**TOWN OF HORIZON CITY
MEMORANDUM**

SUBJECT: On the Final Subdivision Plat application for Verdancia Unit 2 (Case No. SDF25-0003), allowing recording of the final plat prior to the completion of all required improvements secured by sufficient bond and to authorize the Mayor to sign the recording plat, legally described as Being A Portion Of Section 32, Block 78, Township 3, Texas And Pacific Railway Company Surveys, El Paso County, Texas. Containing 69.31 acres \pm . Application submitted by Applicant/Representative: CEA Group.

TOWN OF HORIZON CITY
Planning and Zoning Commission Staff Report

Case No.: SDF25-0003 Verdancia Unit 2 Final

Attachment 4: Final Subdivision Plat (North)

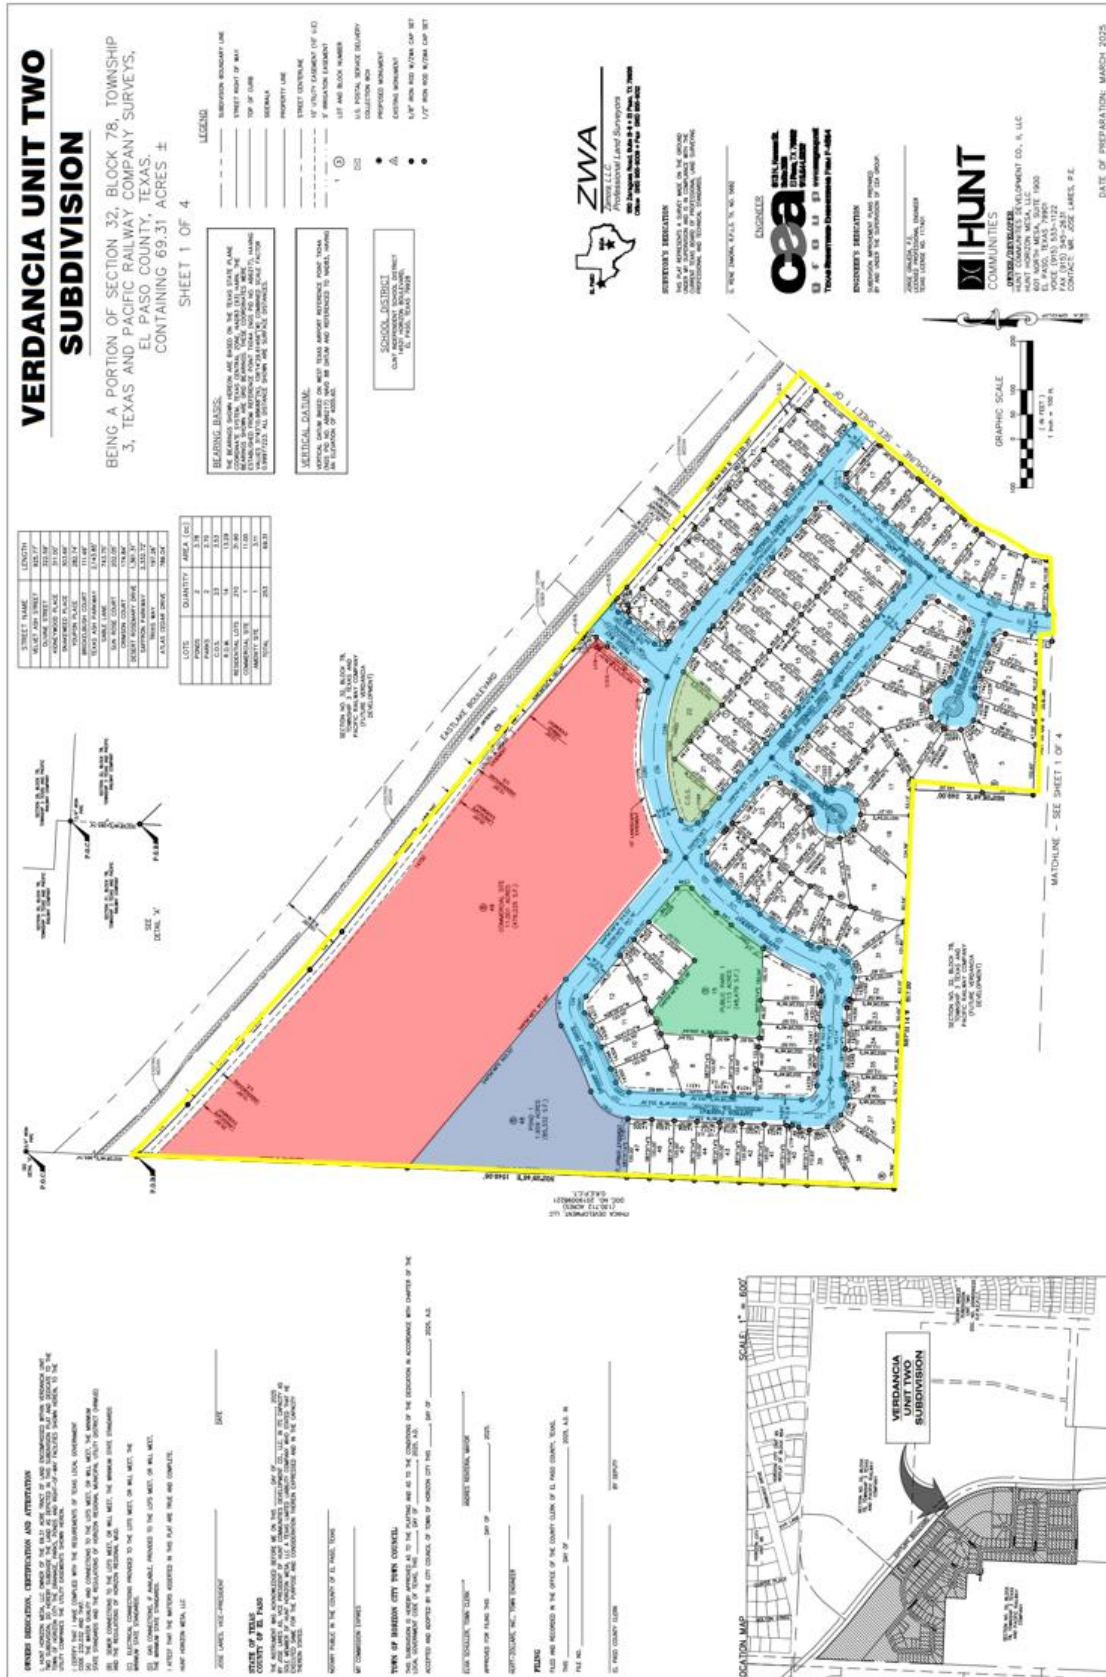
~~Correct blocks in this unit #2 blocks already exist in Unit 1~~

~~This area is very difficult to address because of the curvatures on Eastlake, but if we keep for the area west of this subdivision in the 14300 range and change the addressing on this plat so that it terminates at the 14500 range, this will follow the plan to have the 14600 range begin just east of the intersection of Horizon Blvd and Eastlake Blvd. The area N/E of Eastlake is going to be difficult as we will need to contain the addressing as it eventually turns into the 14700 range east of Rifton. Attached are my recommendations. Please disregard the highlighting of Desert Rosemary. I was going to say that it could follow the addressing on Eastlake at the 14700 range, but that didn't seem like a good idea in the end. Please let me know if you have any questions or suggestions.~~

~~Please update the 12' wide underground easement to 12' wide easement along Eastlake Blvd.~~

~~Change block number~~

Attachment 5: Existing and Proposed Right-of-Way Cross Section and Cul-De-Sacs

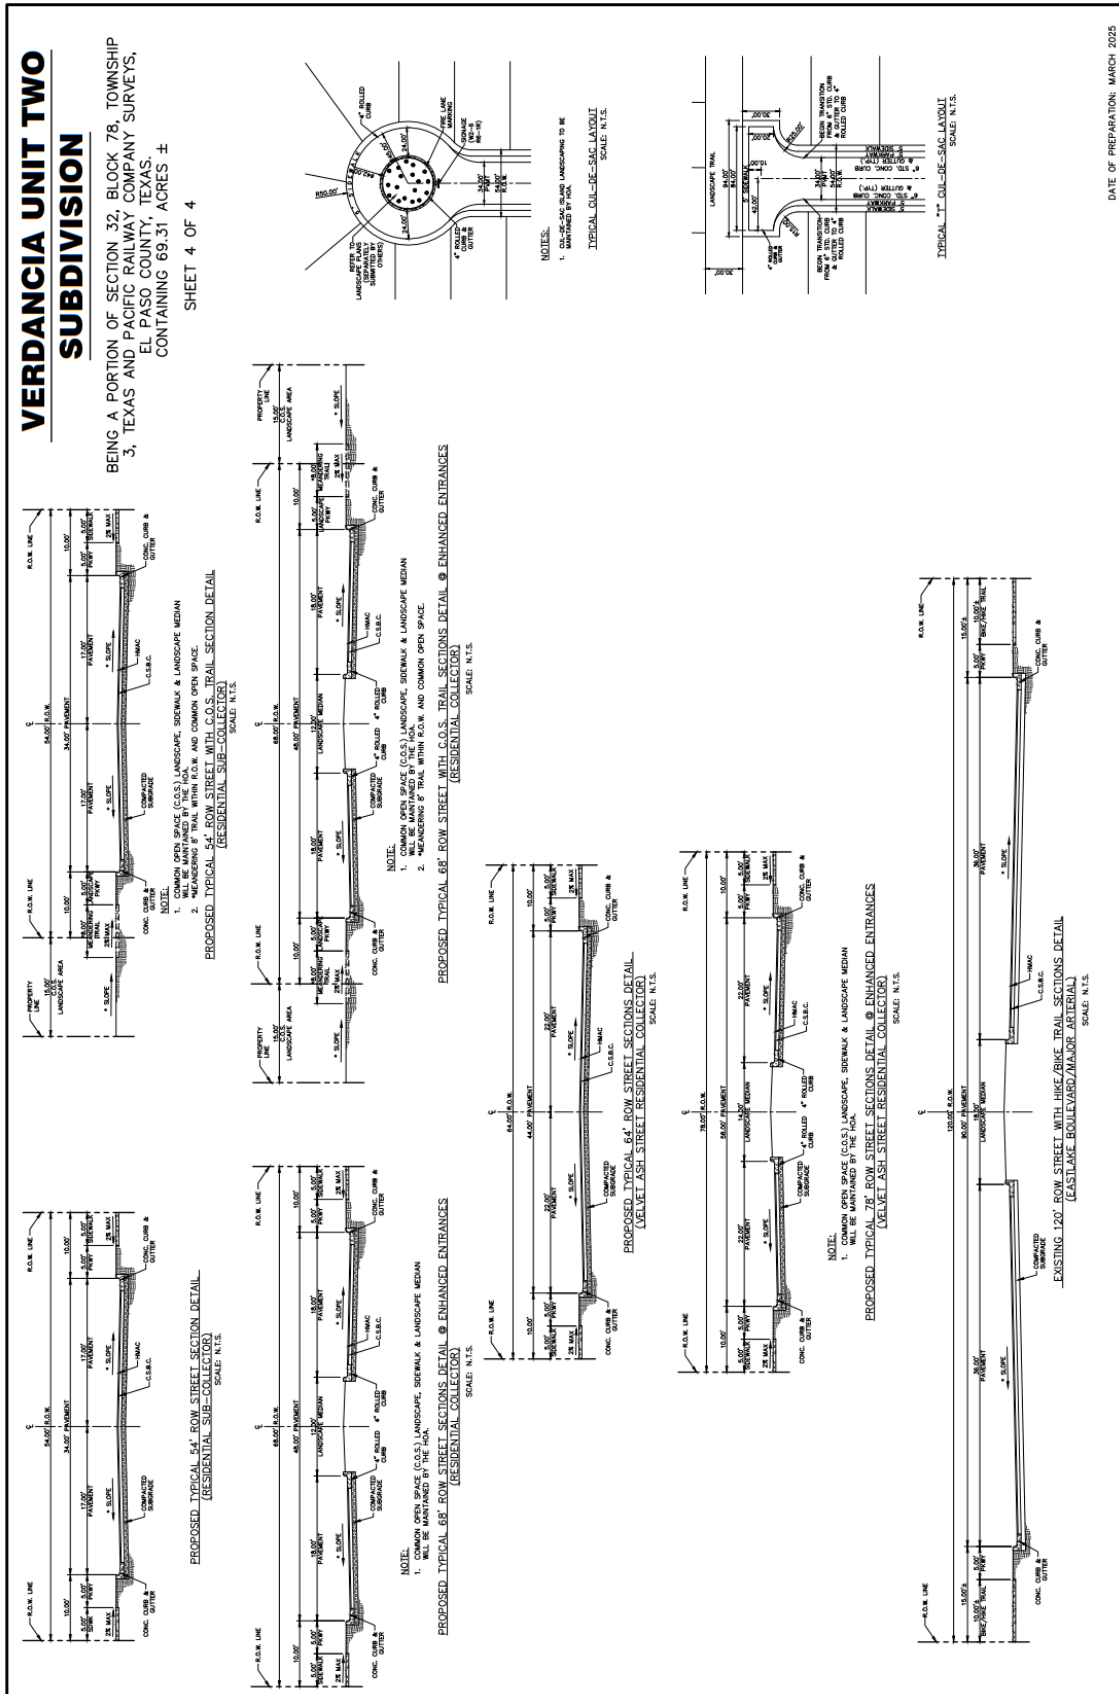
1. Modification from a 52-ft residential sub-collector street right-of-way to a 54-ft street right-of-way at all local residential sub-collector streets. The 54-ft street right-of-way will consist of two 5-ft parkways, two 5-ft wide concrete sidewalks and a 34-ft wide pavement structure with curb & gutter.

2. Modification to use a 54-ft street right-of-way with meandering trails at all local residential sub-collector streets abutting common open space lots. The 54-ft street right-of-way will consist of two 5-ft parkways, 34-ft wide pavement structure with curb & gutter and two 8-ft wide meandering trails. The 8-ft trails will meander within the street right-of-way parkway area and the adjacent 15-ft common open space landscape lot. This will provide a visually appealing and safe walking trail along this corridor. Landscape areas will be maintained by the HOA.

3. Modification to use a 68-ft residential collector at enhanced neighborhood entrances. The 68-foot street right-of-way will consist of two 5-ft parkways, two 5-ft wide concrete sidewalks, two 18-ft wide pavement structures and a 12-ft raised landscape median with curbs & gutter. Landscape areas will be maintained by the HOA.

4. Modification to use a 68-ft street right-of-way with meandering trails at all local residential sub-collector streets at enhanced neighborhood entrances abutting common open space lots. The 68-ft street right-of-way will consist of two 5-ft parkways, 36-ft wide pavement structure with curb & gutter, a 12-ft raised landscape median and two 8-ft wide meandering trails. The 8-ft trails will meander within the street right-of-way parkway area and the adjacent 15-ft common open space landscape lot. This will provide a visually appealing and safe walking trail along this corridor. Landscape areas will be maintained by the HOA.

5. Modification to use a 64-ft street right-of-way residential collector at Velvet Ash St. which consist of two 5-ft parkways, two 5-ft wide concrete sidewalks and a 44-ft wide pavement structure with curb & gutter.

6. Modification to use a 78-ft street right-of-way residential collector at the enhanced neighborhood entrance on Velvet Ash and Eastlake Blvd. intersection. The 78-foot street will consist of two 5-ft parkways, two 5-ft wide concrete sidewalks, two 22-ft wide pavement structures and a 14-ft raised landscape median with curbs & gutter. Landscape areas will be maintained by the HOA.

7. Modification to use 50-foot radius Cul-de-Sac streets with interior landscape islands and outside travel lane roadway width of 24-feet. The proposed cul-de-sac and landscape islands will enhance the neighborhood character, reduce the impervious surface, aid to eliminate typical cul-de-sac "stack" parking and maintain adequate room for emergency vehicle turning movement. Landscape areas will be maintained by the HOA.

8. Modification to use "T" Cul-de-Sac access streets on Kidneywood Place, Snakeweed Place and Youpon Place. The proposed "T" Cul-de-Sac will consist of a 54-foot right-of-way within the straight segment with 34-ft pavement width, two 5-ft parkways and two 5-ft wide concrete sidewalks. The "T" hammer head section will consist of a 94-ft width right-of-way, width an 84-ft wide pavement section and 5-ft sidewalks on each end. The length of these "T" Cul-de-Sacs will vary between 285-ft to 311-ft from center of intersecting street to center of "T" Cul-de-Sac.
